Ualena Option Follow-Up Responses to FTA Comments

Figure 5-6 KelehiLageon Beach Park.—Project and Features

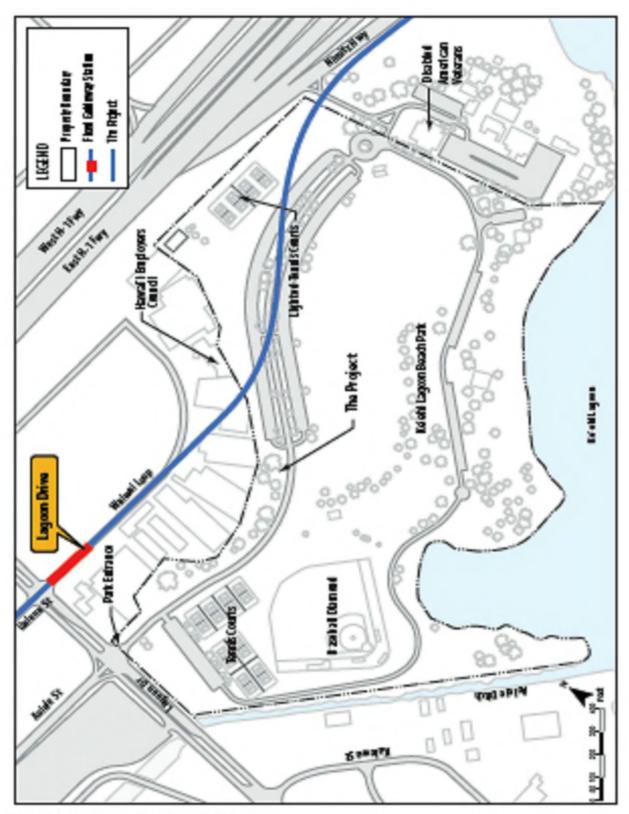
2. Describe how, in developing the avoidance alternative, efforts were made to minimize impacts on property acquisitions, privately owned businesses, historic properties, and Keehi Lagoon Beach Park. We also note that the DEIS did not document the 4(f) effects at Keehi Lagoon Park as de minimis. FTA has yet to make a section 4(f) finding and we will need additional information to assist us in our finding.

All of the recreational features, attributes, and activities of the park, other than the four lighted mauka tennis courts, are located makai and away from the Project. The Project will traverse the park near its mauka property line, generally following the alignment of the park's access road until it leaves the park, where it continues on an elevated guideway within the right-of-way of Nimitz Highway. In the park, the Project guideway will be approximately 30 feet wide, between 30 to 35 feet high, and will be elevated above approximately 1 acre of land within the park, primarily in the parking lot and the park access road. Within the park, the guideway will be constructed on approximately 10 columns that will be about 6 feet in diameter, which will result in the use of approximately 280 square feet of park land for the placement of columns.

Measures to minimize harm were considered in the Project's design in coordination with the DPR. To minimize project use of the park, the project guideway was designed as close to the mauka boundary as possible, consistent with operational and engineering constraints, and to be away from the recreational activities and facilities, including the baseball diamond, open field, paved walking path, picnic areas, pavilion, and access to the water where canoeing events occur and most of the tennis courts are located. The views of the water by park users will not change with the Project. Looking mauka, near the water, the Project will be slightly more visible than the H-1 Freeway in the background and will not noticeably change the character of the landscape (Figure 4-27 in Chapter 4 of this Final EIS).

The Project guideway was designed with the minimal curve radius needed to maintain efficient system operation to serve the Lagoon Drive Station, while minimizing impacts to the park. The support columns have been designed to use as little park land as practicable, be located in areas away from recreational activities, and accommodate access to the park by recreational users. The alignment is designed to be elevated above the parking area, and there will be no net loss of parking spaces.

None of the 12 tennis courts will be permanently used by the Project. The guideway will cross above the park, just makai of the four lighted mauka tennis courts near Nimitz Highway, as shown in Figure 5-8. Given their proximity to the guideway, these tennis courts will be closed during construction and reopened as unlighted tennis courts when this portion of the Project is completed. DPR's desire is to have lighted tennis courts available for evening use. To accomplish this and mitigate temporary impacts to these lighted mauka tennis courts, RTD will coordinate with DPR during Final Design to provide lighting and associated resurfacing for four of the tennis courts near the park entrance prior to construction so that nighttime tennis court use will be maintained during construction and after project completion. The lighting will be designed and constructed in accordance with regulatory requirements.
